**ARKANSAS NUCLEAR ONE  
APPENDIX R  
REGULATORY CONFERENCE**

**July 10, 2003**

# **Fire Modeling in the 4KV Switchgear Room (Fire Zone 99-M)**

## High-energy Switchgear Arcing Fire

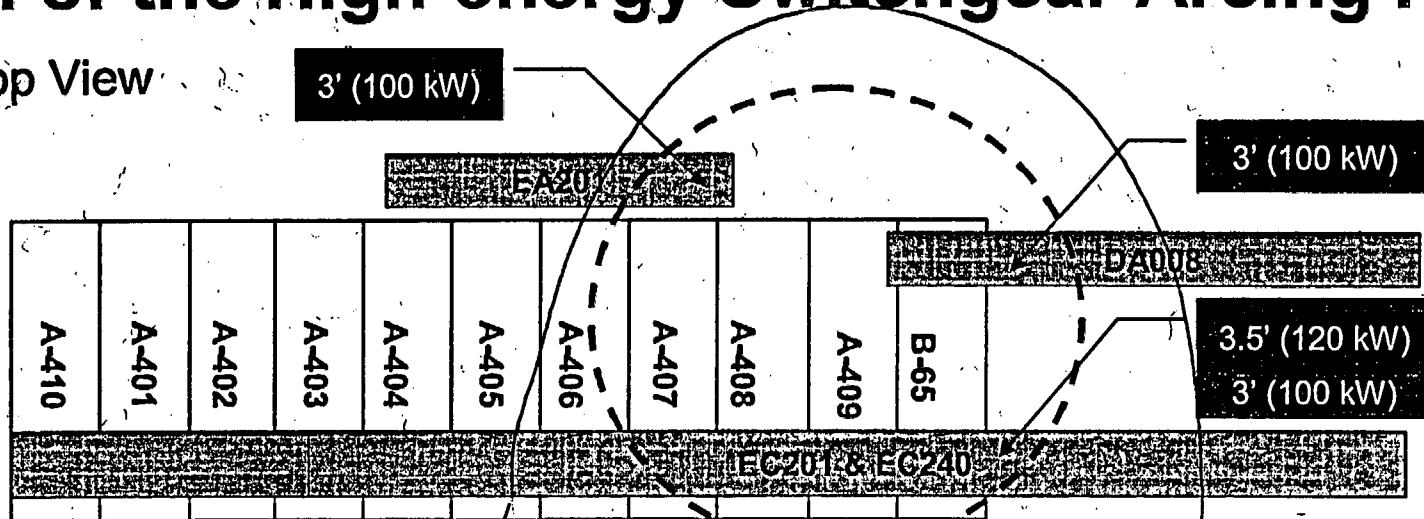
What?

basis

## ZOI of the High-energy Switchgear Arcing Fire

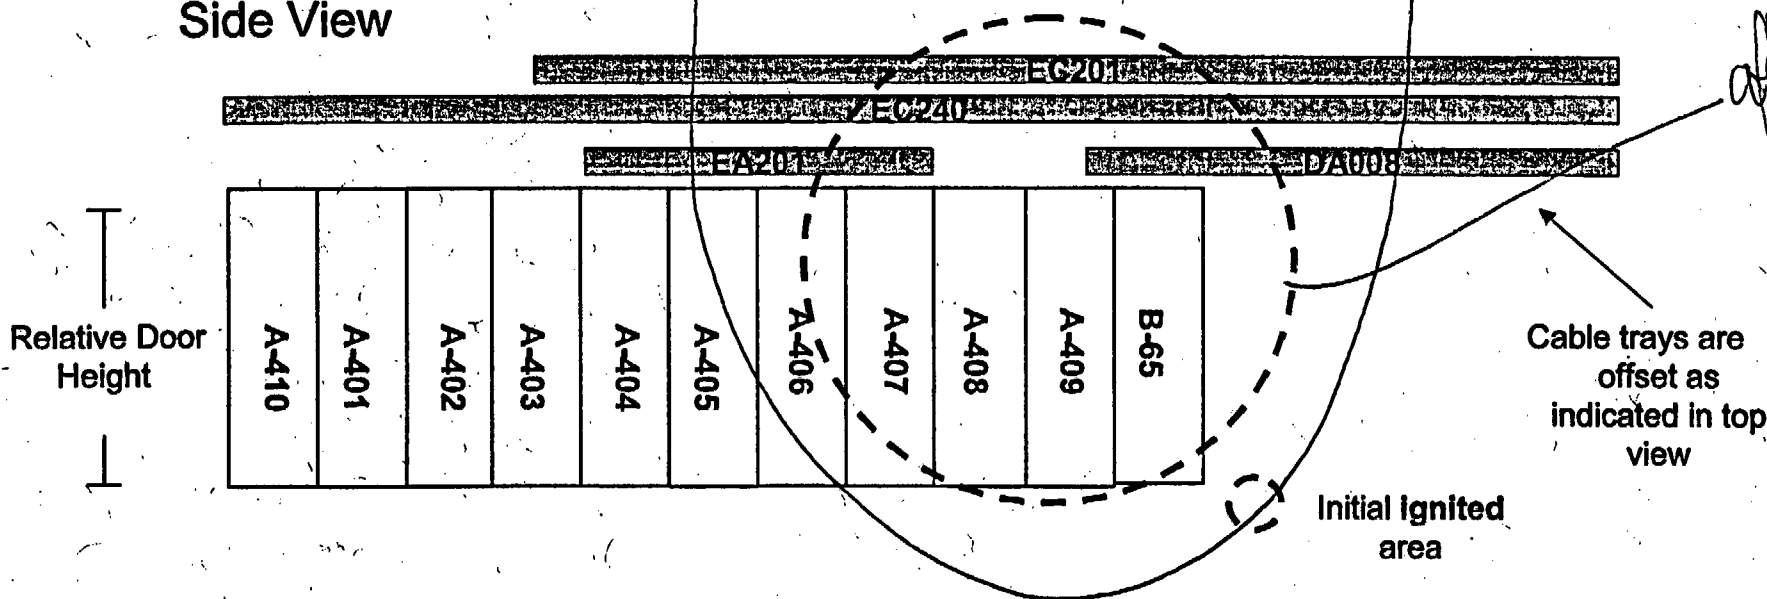
*How about 2 MW*

*about 10' x 10' for 408  
may be cable  
but not  
cable tray  
but 4-12*

# Fire Modeling: Target Damage/Ignition

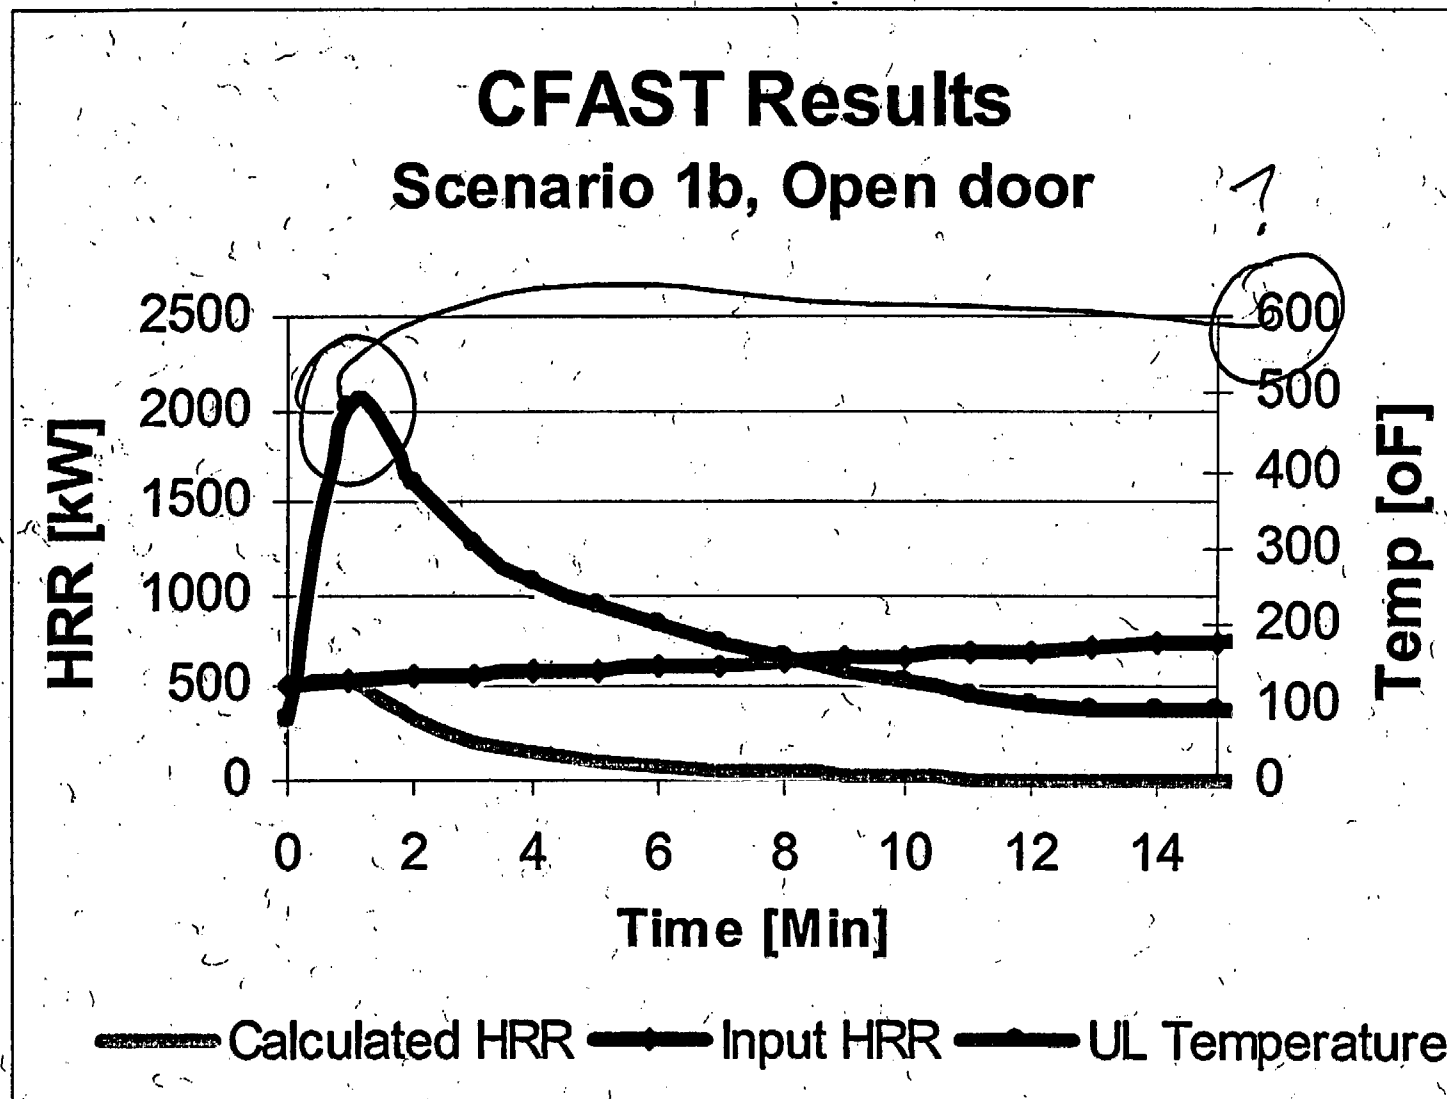
*What is actual configuration*

*What OE did you perform*
